Product Change Notice (PCN)

PCN Number: **PCN-0456180R-02**

Product(s) Affected: *PJ-041H*

PREVIOUS CUI DEVICES DETAIL / IMAGE	NEW CUI DEVICES DETAIL / IMAGE

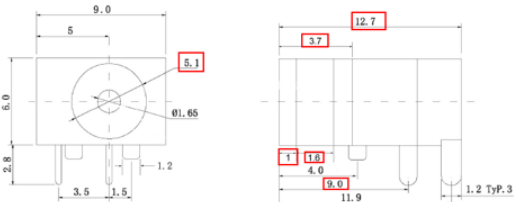
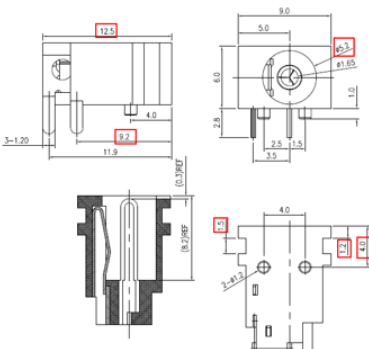
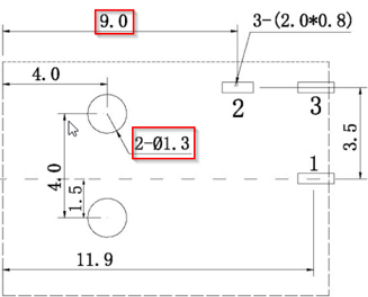
Description of Change: *New Factory Location. Product re-engineered for improved manufacturability and production yield. See image below for reference and check CUI Devices website for updated drawing. Cosmetic differences may be visible and not affect the form fit and function of the product.*

PREVIOUS CUI DEVICES DETAIL / IMAGE			NEW CUI DEVICES DETAIL / IMAGE		
DESCRIPTION	MATERIAL	PLATING/COLOR	DESCRIPTION	MATERIAL	PLATING/COLOR
center pin	brass	silver	center pin	copper alloy	silver
terminal 1	brass	silver	terminal 1	copper alloy	silver
terminal 2	C5191 phosphor bronze t=0.30	silver	terminal 2	copper alloy	silver
terminal 3	C5210 brass t=0.30	silver	terminal 3	copper alloy	silver
housing	PA66 (UL94V-0)	black	housing	PPA (UL94V-0)	black

<p>MATING PLUG Jack Insertion Depth 8.9 mm</p>	 <p>MATING PLUG Jack Insertion Depth 8.2 mm</p>
---	--
